C.3 CULTURAL RESOURCES CONSULTATION

Re: Project review under Section 106 of the National Historic Preservation Act of 1966
Notification of Project and Proposed Phase I Cultural Resources Inventory Scope of Work for the
W.A. Parish Post-Combustion Carbon Capture and Storage Project in Southeastern Texas (Fort
Bend, Wharton, and Jackson Counties)

Subject: Response to Texas Historical Commission Request for Backhoe Trenching;
Proposed Phase I Cultural Resources Inventory Scope of Work for the W.A.
Parish Post-Combustion CO₂ Capture and Sequestration Project in
Southeastern Texas (Fort Bend, Wharton, and Jackson Counties)

Big Creek HDD Entry/ Exit Points

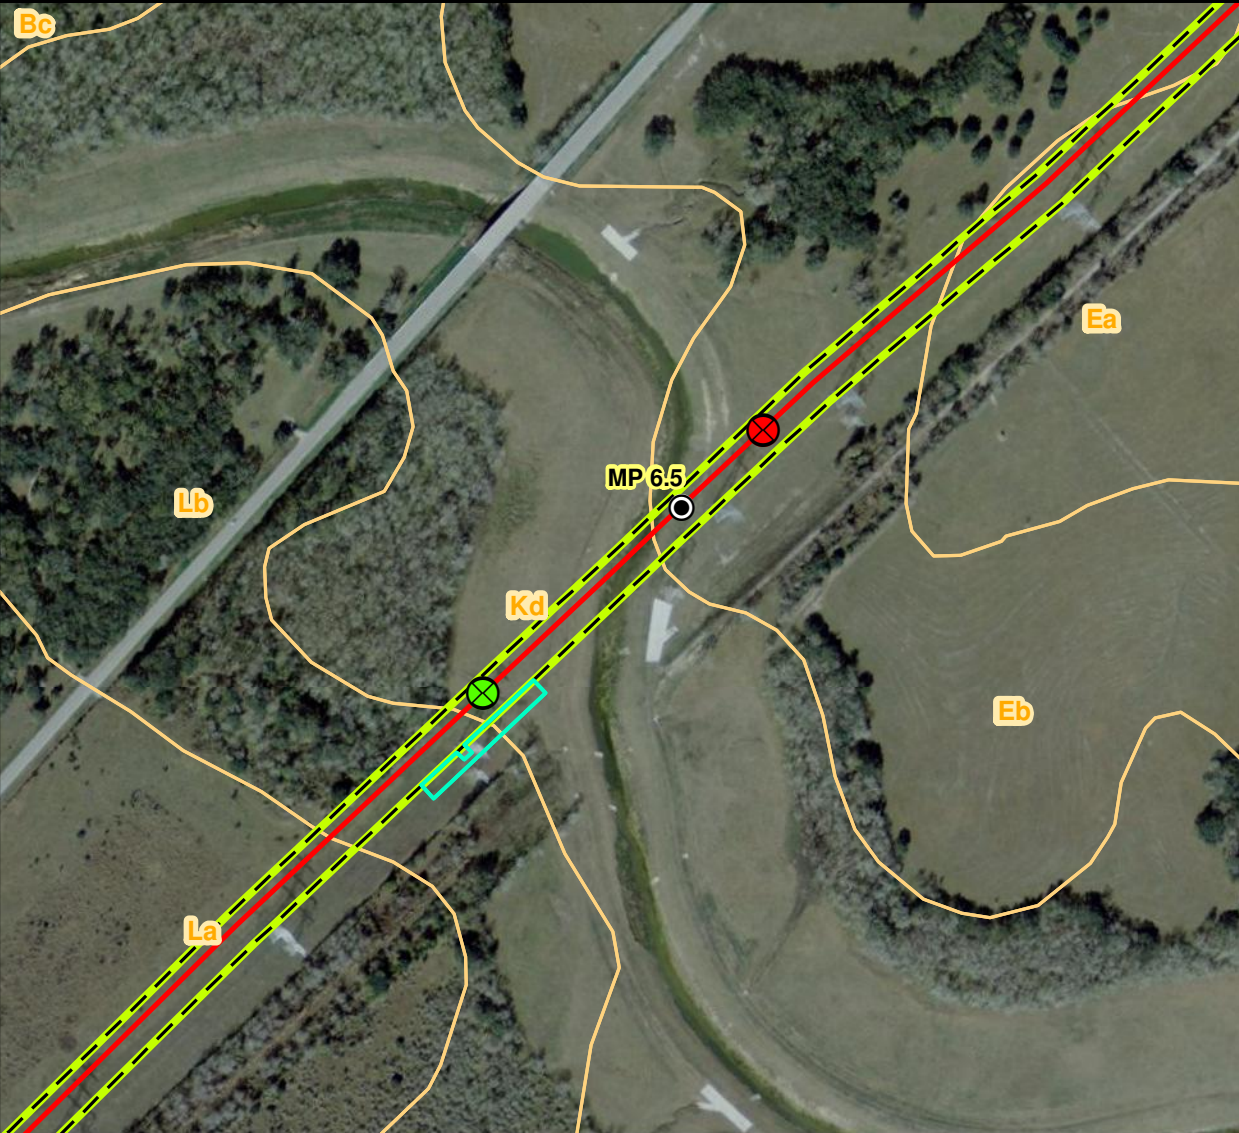
The review staff, led by Jeff Durst, has examined our records. According to our maps, the proposed project area should be surveyed as recommended by URS Group, Inc. (URS). However, we recommend, in addition to the procedures outlined in the URS scope of work, that backhoe trenching be conducted in areas adjacent to waterways where there is the potential for deeply buried cultural resources. In areas where directional drilling will be utilized to pass underneath waterways backhoe trenching should take place at the location of the bore holes entrance and exit points where deep sediments are observed or suspected. In instances where deep sediments are not encountered in these areas then this should be explained in the report as the reason why backhoe trenching was not conducted.

The FM 1994 HDD would cross under a man-made pond and would be completed in Bernard-Edna Complex soil (Table 1), which is associated with an upland landform. Therefore, the U.S. Department of Energy (DOE) proposes that no deep testing would be required for the FM 1994 HDD. Additionally, the HDD exit points for the Big Creek and Lavaca River crossings are characterized by the Edna fine sandy loam and Telferner fine sandy loam, respectively (Table 1). Both of these soils are affiliated with ancient (i.e., pre-Holocene) meander ridges on the Beaumont Formation. Based on their landform characteristics and age, no additional deep testing is considered warranted for the HDD exit locations at the Big Creek and Lavaca River crossings.

The soils encountered at the remaining eight HDD entry and exit locations (i.e., the entry locations for the Big Creek and Lavaca River HDDs and the entry and exit locations for the San Bernard River, Colorado River, and Jones Creek HDDs) are associated with well-defined floodplain deposits that may contain more deeply buried cultural resources. As recommended by THC, DOE proposes that additional deep testing via backhoe trenching be conducted at these eight locations. Table 1 summarizes the recommendations for each HDD entry and exit location.

| HDD Name | MP | Entry Location | | | Exit Location | | |
|-------------------|------|----------------|--|-----------------------|---------------|-------------------------------|-----------------------|
| Big Creek | 6.5 | Kd | Kaman clay | Yes | Eb | Edna fine sandy loam | No |
